ROADSTER WARRANTY Bulletin

Subject: **Stabilizer Bar Link Rods**

No. **2013-6**

REVISION 1
July 15, 2013

GOOD PART WITH A PAINTED DOT

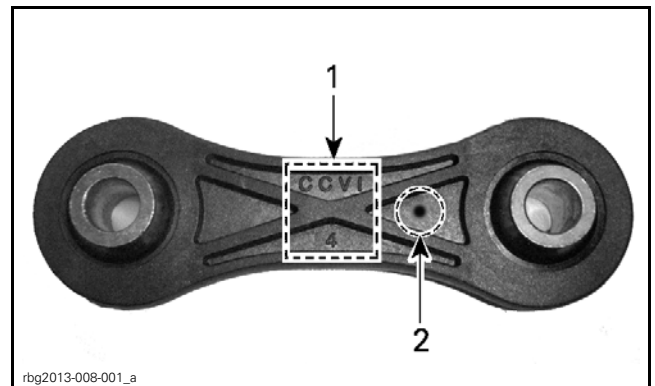
Some vehicles have been produced with weak stabilizer bar link rods.

Remove and inspect each link rod to find their production number.

If production number shows a "4", as **CCVI 4** **WITHOUT** a painted dot.

If link rod shows a production number 4 **with a painted dot** or if link rod shows a production with number 1, 2 or 3.

REPLACE

DO NOT REPLACE

1. Production number
2. Painted dot
